B2HAMD2Doc10 DPO Public Comment_McCarthy S_2024-04-26	7
1 B2HAMD2Doc10 DPO Public Comment_McCarthy S_2024-04-26	7
1.1 B2HAMD2 DPO Public Comment_McCarthy_2024-26-2024	7

Boardman to Hemingway
Transmission Project
Request for Amendment 2

Subject: Comment One submitted by Irene Gilbert on behalf of the public interest and herself as a petitioner regarding the Draft Proposed Order for the Boardman to Hemingway Transmission Line, Amendment 2

Figure 4-1
RFA2 Proposed Micrositing
Area Additions
Union County

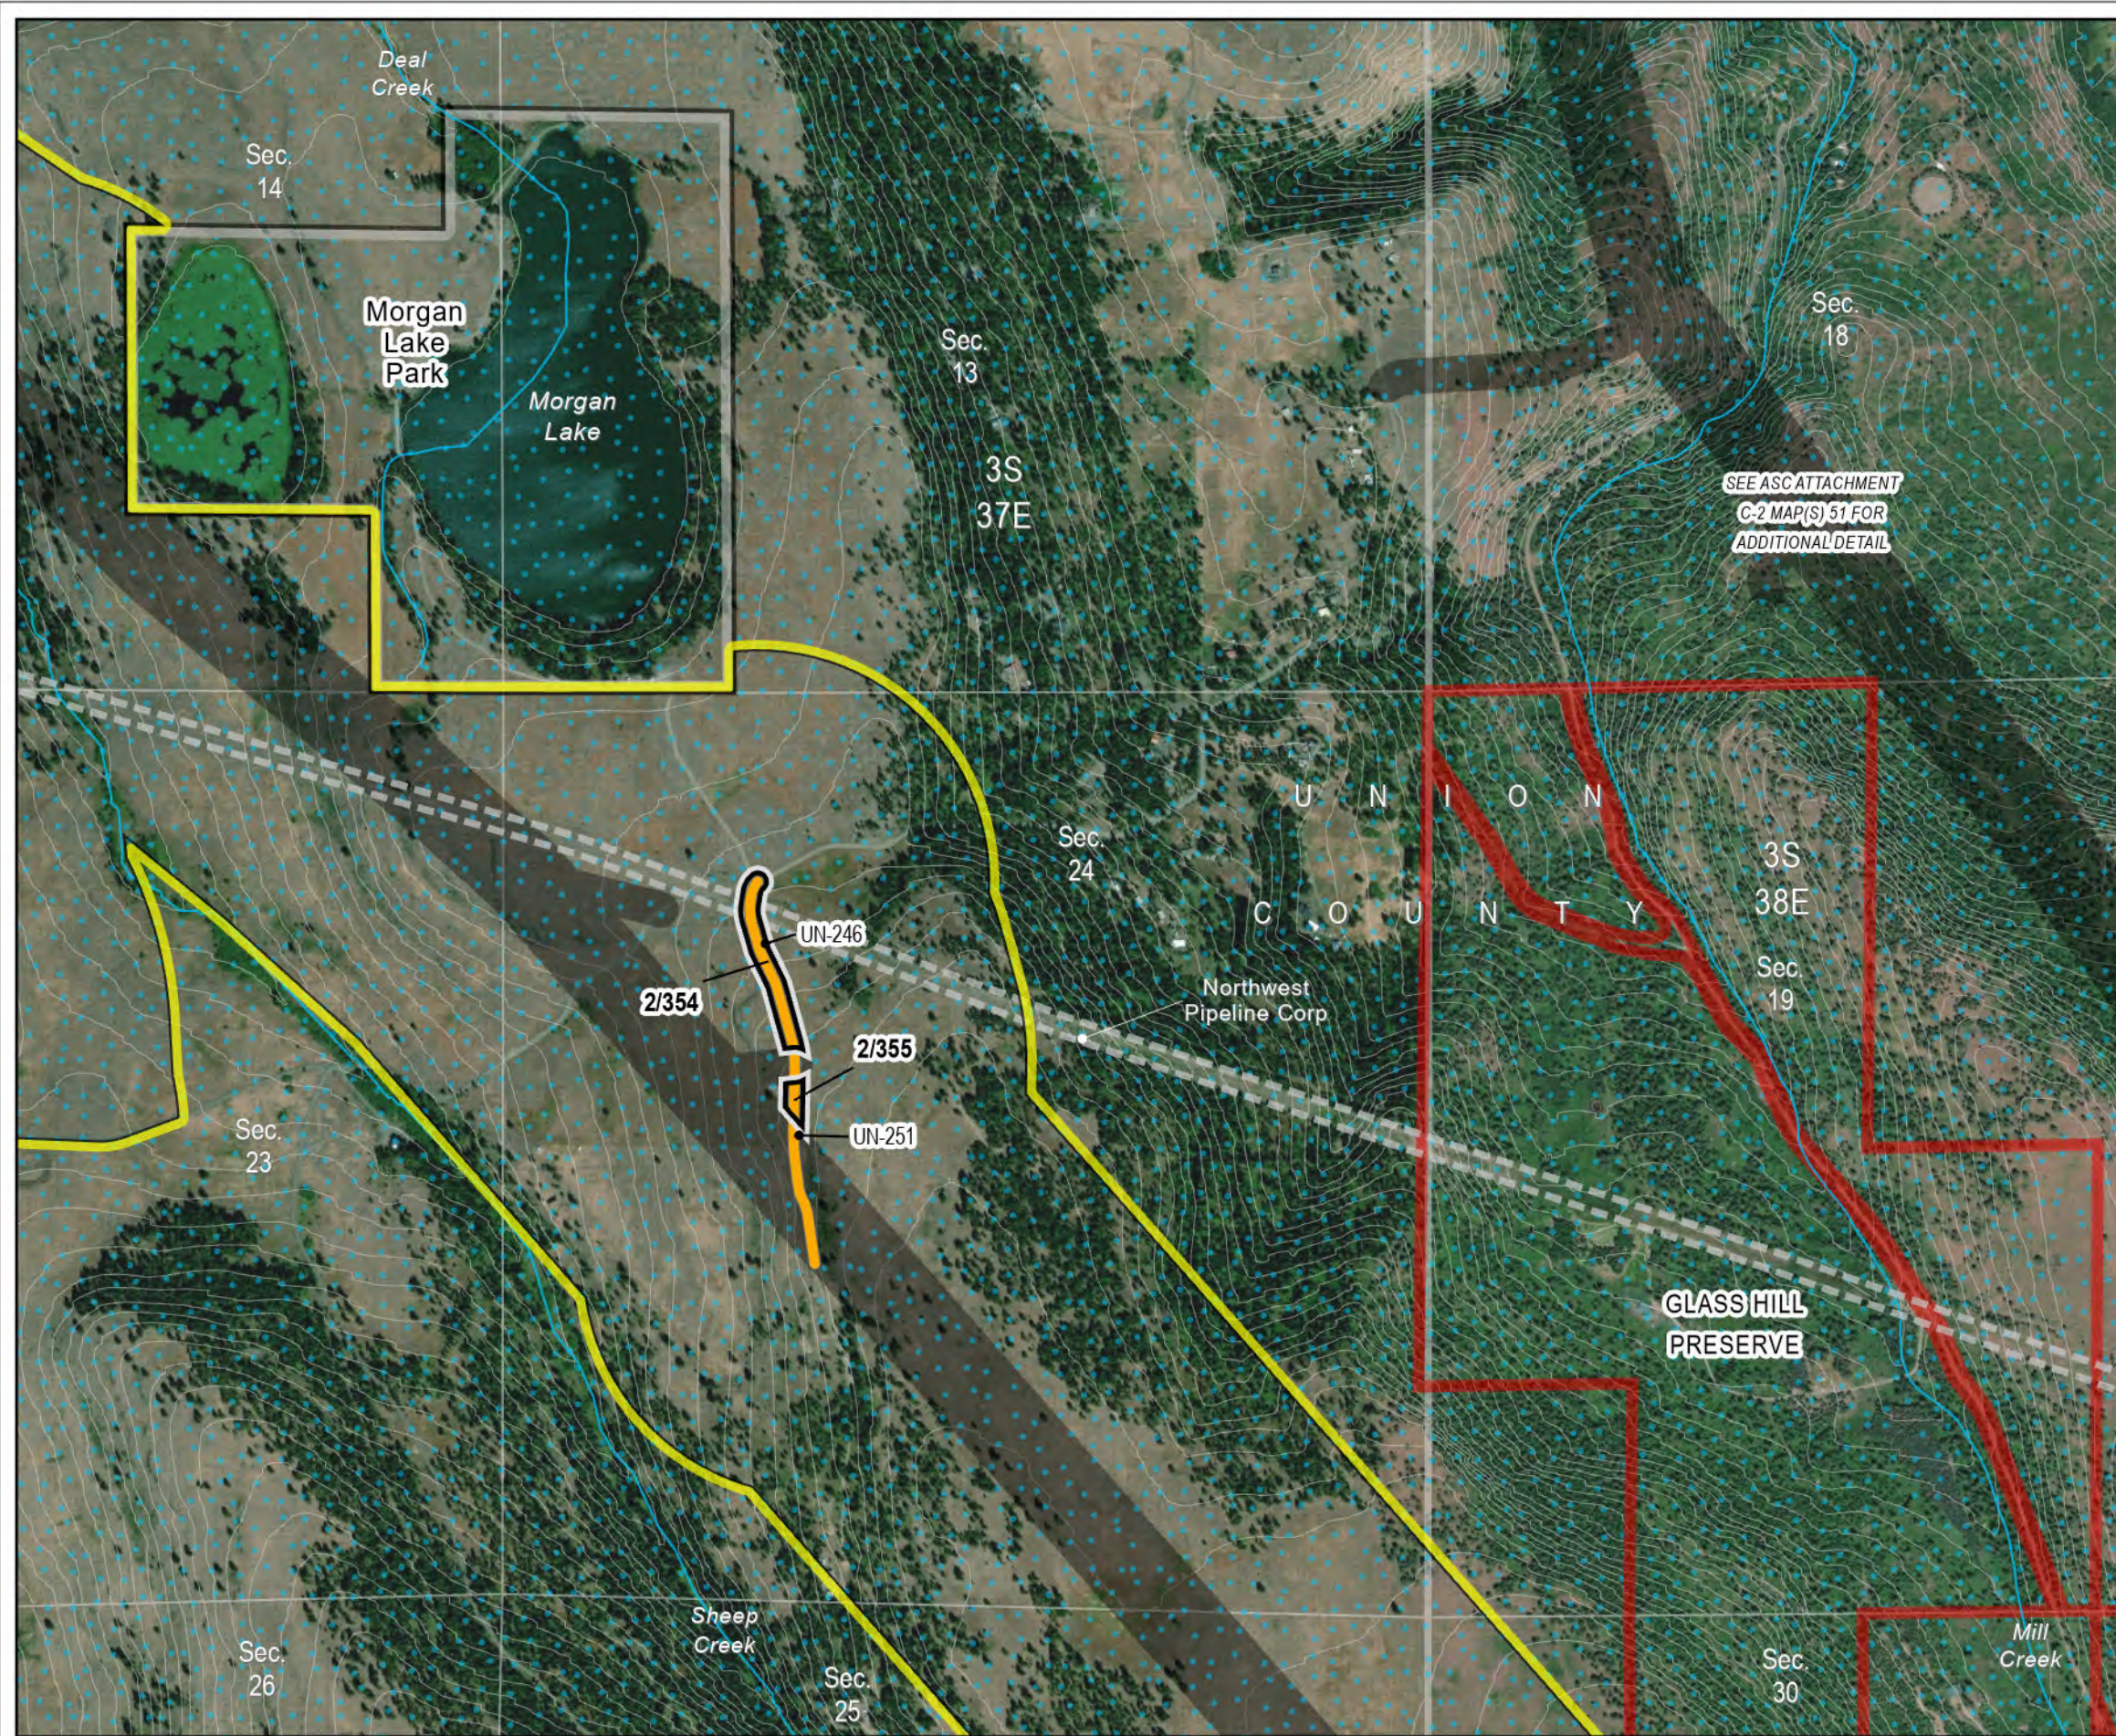
I'm attached a couple maps from RFA2 which show the land parcels under your name as well as the proposed changes within the vicinity of your property. It appears that the changes proposed in RFA2 within the vicinity of your property include slightly modified temporary pulling and tensioning sites and a minor adjustment (moving further away) of the previously approved 230 kV rebuild in the area. As part of RFA2, Idaho Power requests to expand the site boundary as well as add new micrositing areas. The expanded site boundary is an area that is evaluated for resources, however, the proposed micrositing areas are the areas where actual

facility components would be located or temporary would be conducted, if Council approves the changes. So, no facility components would be located in the expanded site boundary area (yellow line on the Figure 4-1). Mailed notices were sent to property owners within 500 feet of the site boundary, so that is why you received the notice. But the primary previously approved location of the transmission line is not changing. Let me know if this helps and you have any additional questions. I will save your comment and my response on the record for the DPO and pass it along to Idaho Power.

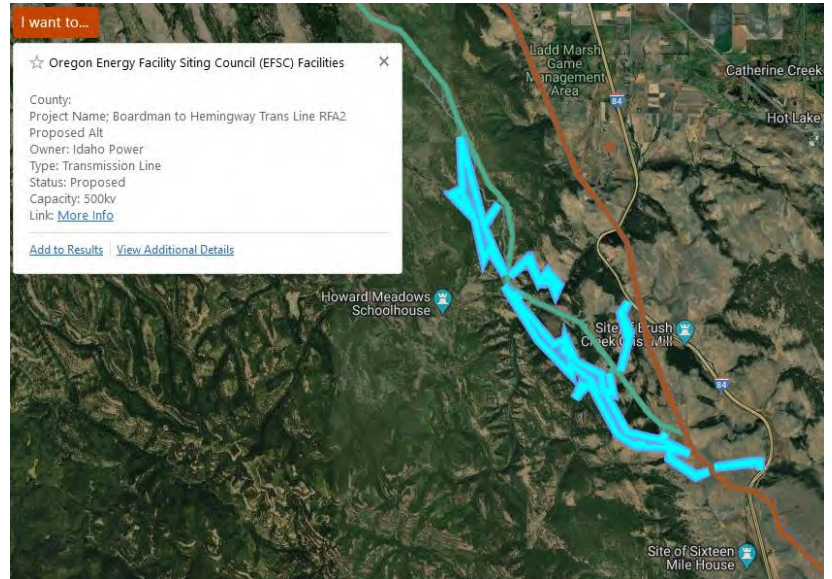
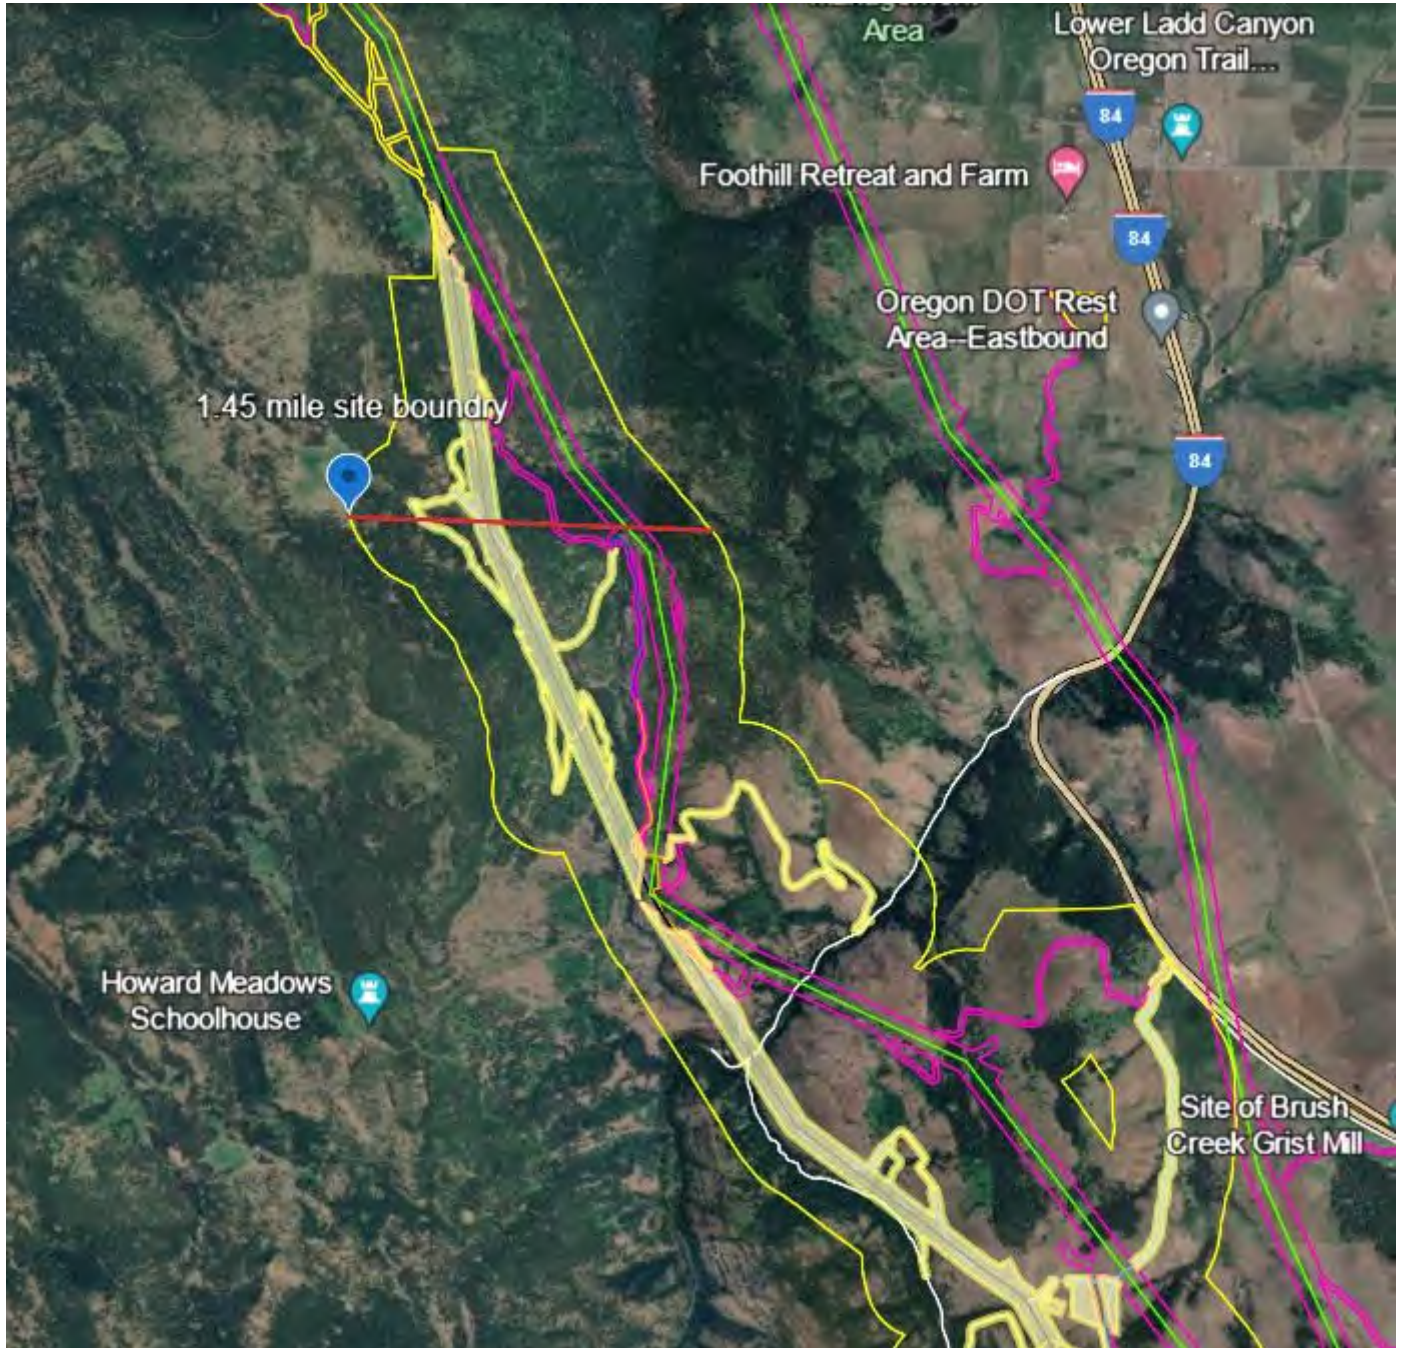
What follows are an electronic and paper map comparison of the Glass Hill Preserve. As the maps are currently drawn, we cannot locate and put together all the parcels in the Glass Hill Preserve. The Glass Hill Preserve, in RFA 2, is now a protected area. Therefore, we are unable to determine the impacts of RFA 2 on the preserve. This information needs to be made public in digital form so an analysis can be done. STOP proposes a new Site Condition to remedy this situation, see below, Recommendation 4.

1. [Figure 4-1 RFA2 Proposed Micrositing Area Additions](#) (scale 1,000 feet) -- pages 35, 37, and 38 skipping 36.³⁰ The full boundary of the Glass Hill Preserve cannot be determined by putting these 3 pages together.
2. Figure 8-1 Proposed Site Boundary (scale 2,000 feet) and pages 29, 30, and 32 skipping 31 (again). The full boundary of the Glass Hill Preserve cannot be determined by putting these 3 pages together.

This again demonstrates that the public using the maps, and for those able to get and use the KLM files, they still cannot find valuable and important pieces of information. Therefore, the requirements for mapping in the OAR's, the Second Amended Project Order, Section III(c), and Exhibit C, Application for a Site Certificate, it is clear that the legal requirements bestowed on the Department are not being met and the department must find a way to meet those standards before this amendment goes forward.

Figure 1: Close up on Map 38 from 2024-04-11-FIG-4-1-RFA2-Micrositing-Additions-and-Expanded-Site-Boundary-MAPBOOK

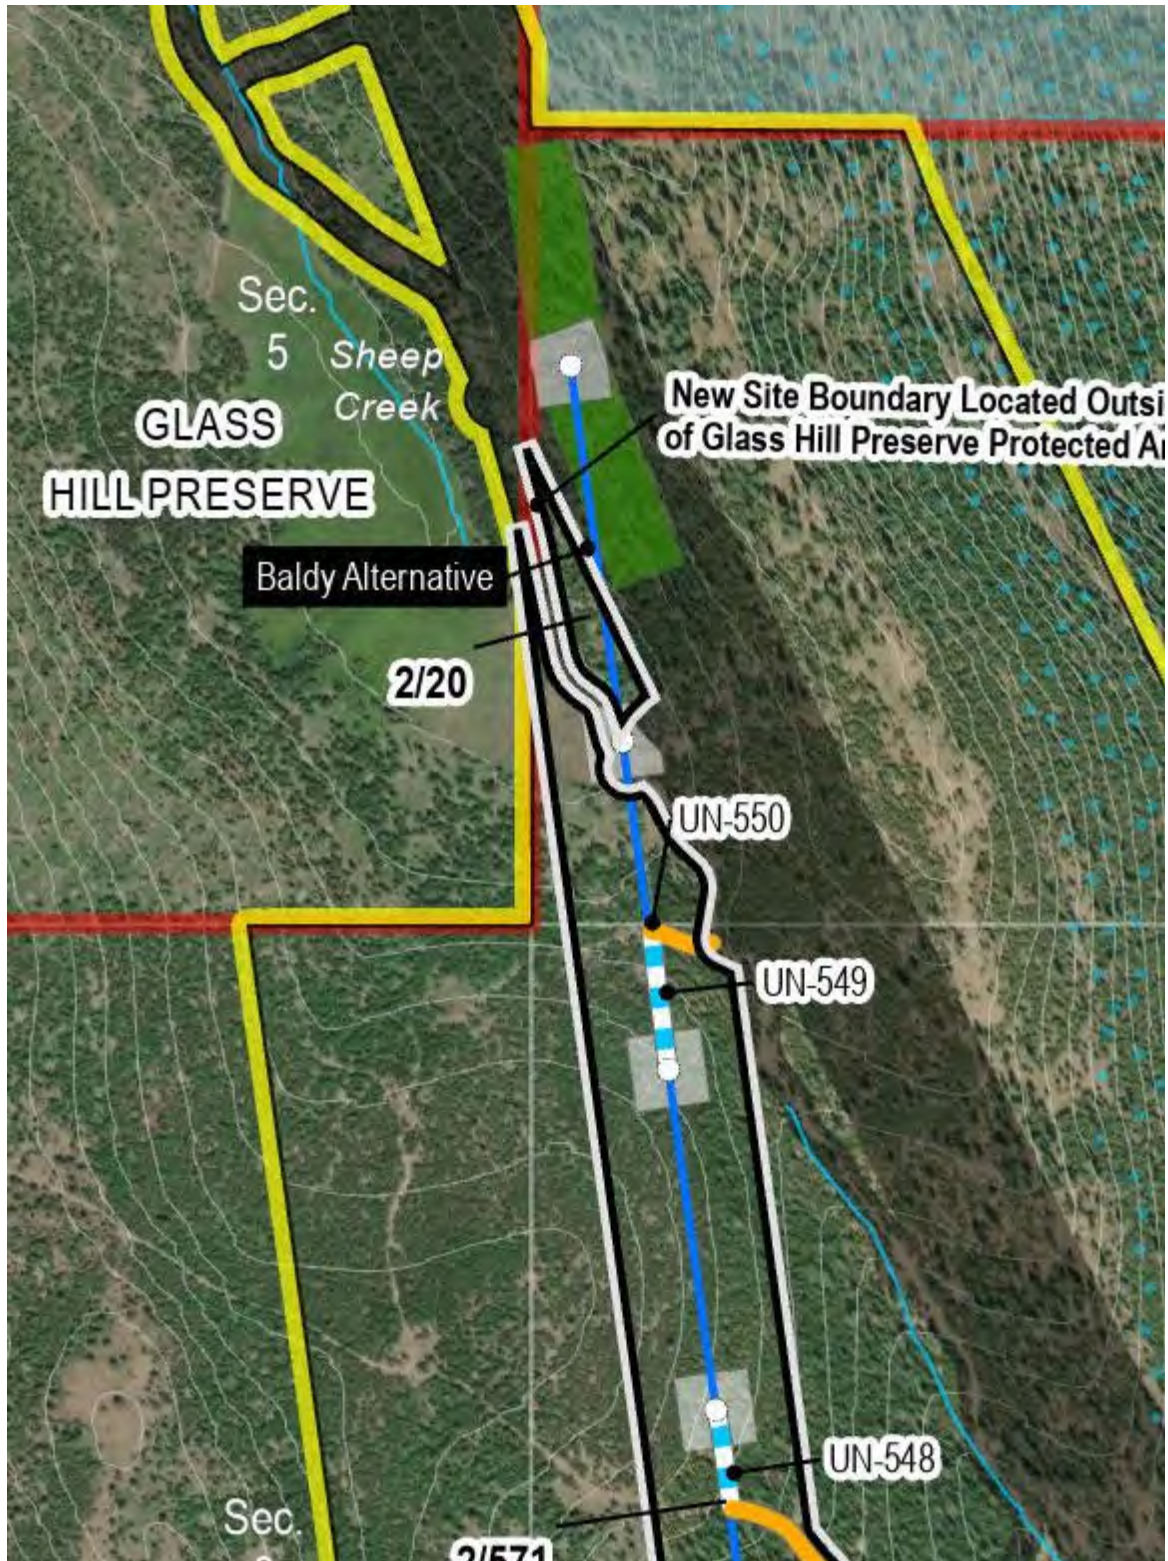
Proposed route changes in RFA2 (Baldy Alternative) would cut across the head of Winn Meadows ([Appendix Figure 1](#)), adding micrositing areas to this pristine wet meadow in a roadless area. Major disturbance and impacts were introduced under RFA1; [Appendix Figure 2](#) shows the transmission line and access roads in Sections 5 and 32 erroneously approved to go through Glass Hill SNA. RFA1 called these roads “existing roads”. I was confused about the location of these “existing” roads when I read RFA 1, and now realize these are old logging roads which have not been used for 40 or more years. RFA 2 would expose even more of the perimeter of Glass Hill SNA to disturbance from construction and ongoing maintenance of the B2H. The cumulative impacts of the RFA 2 added to the disturbance permitted under the ASC and RFA 1 are profound.

Map 30 of Figure 8-1 2024-04-11-FIG-8-1-RFA2-RFA1-ASC-Expanded-Site-Boundary-Changes-MAPBOOK and Map 38 of 2024-04-11-FIG-4-1-RFA2-Micrositing-Additions-and-Expanded-Site-Boundary-MAPBOOK shows the proposed site boundary cutting through Glass Hill SNA in several places, fatally damaging the integrity of the natural area. Confusing additional access roads were added in RFA1. In the Winn Meadow area, “existing roads” are shown on a map, yet those roads no longer exist on the ground and have not been driven in over 40 years. This should never have been allowed under the EFSCs rules for Protected Areas.

Figure 4: Blue hatched polygon is approximate area where *Pyrrocoma scaberula* is known to occur near Morgan Lake. Surveys are needed.

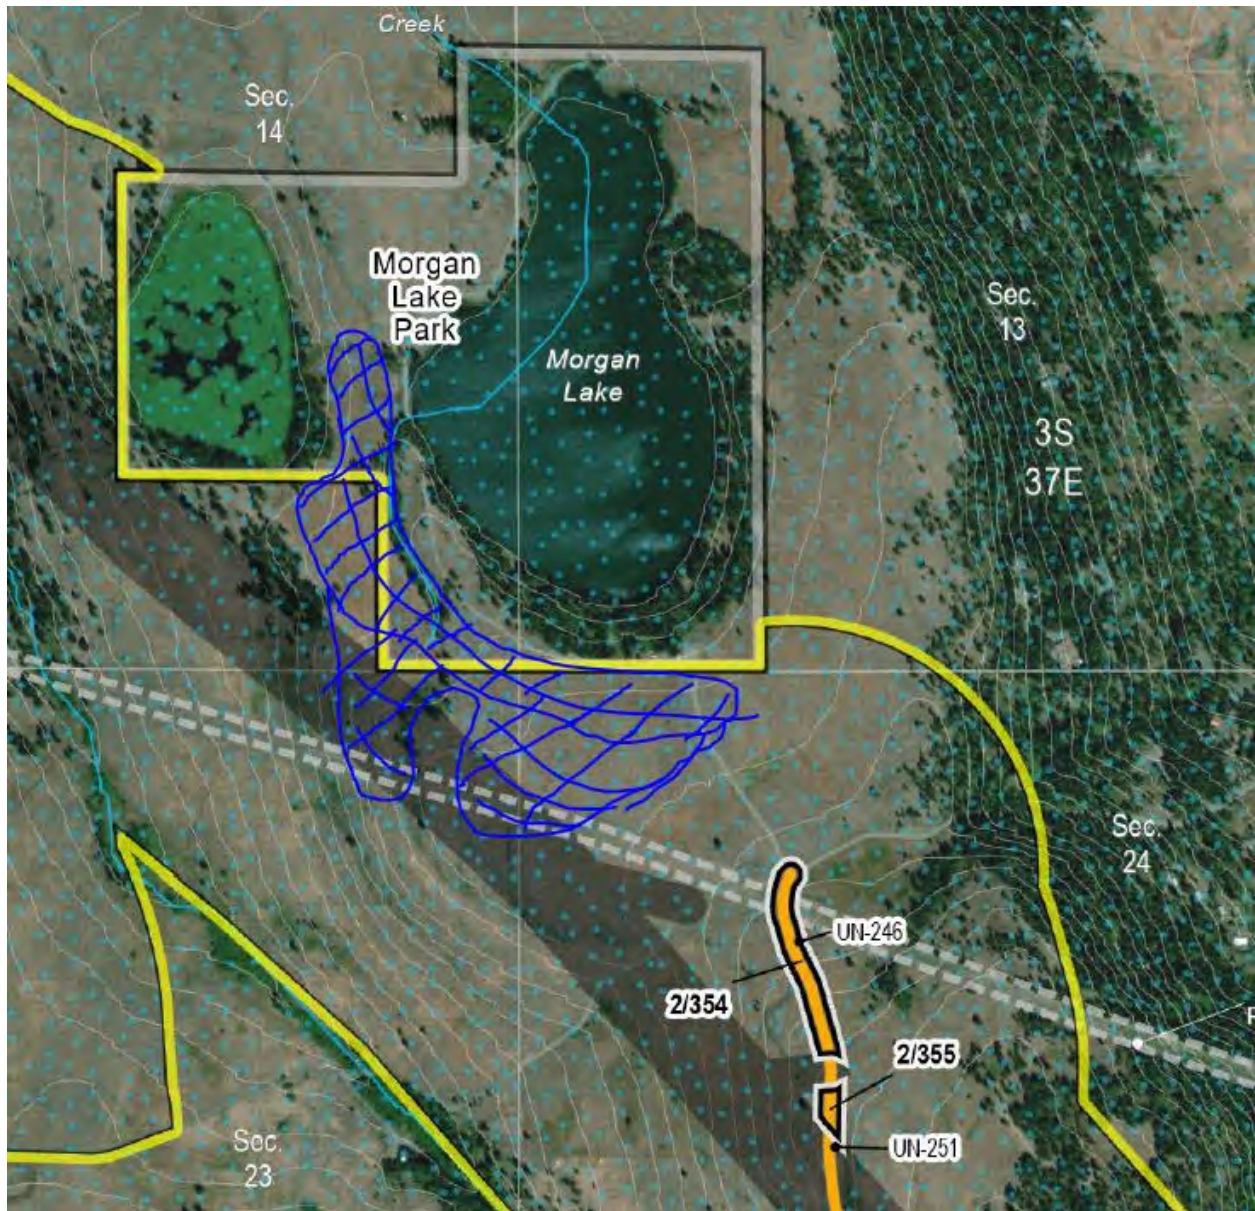
The largest known occurrence of the species is known from within the RFA2 expanded Site boundary in and near Morgan Lake Park ([Appendix Figure 4](#)). I submitted herbarium specimens to WSU and OSU (identity confirmed by Dr. James Mickley, Herbarium curator; it is most likely a new variety or a subspecies). Siting forms are on their way to Oregon Biological Information Center, yet much more survey is needed. It grows only in unique mesic grasslands. There were never many of this type of grassland, and fewer remain today after agriculture and development. It is likely that rough goldenweed occurs in the Morgan Lake Alternative original site boundary/micro siting area. Surveys are needed to document the extent. As of May 3, 2024, this species is listed as Endangered by the State of Oregon rare plant program. Under the EFSC standard
